THE ROVER COMPANY LIMITED

LAND-ROVER SERVICE NEWS LETTER Vol. 2 No. 15

December 1966

Fig. 1. Wire mesh guard, front illustrated.

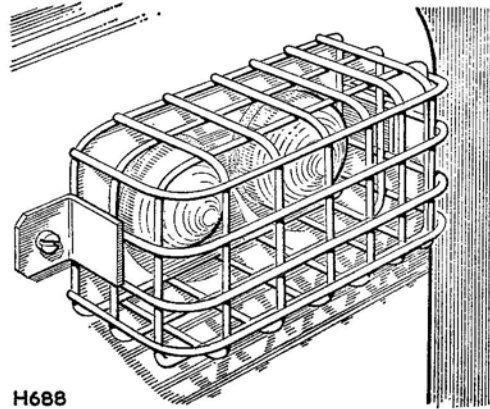
MODIFICATION: Introduction of wire mesh guard for the protection of side, stop and flasher lamps.

REMARKS: The above wire mesh guard and fixings are now available from our Parts Department. The guard can be fitted to all Series II and IIA vehicles, but they cannot be used on the front wings when jerrican holders are fitted.

PART NUMBERS:	Wire mesh guard for side, stop, tail and flasher lamps	4	320626
	Screw (2 BA x ½ in. long)		8	77869
	Plain washer	} Fixing guard to front wings or rear body	8	3816
	Spring washer		8	3073
	Nut (2 BA)		8	3823
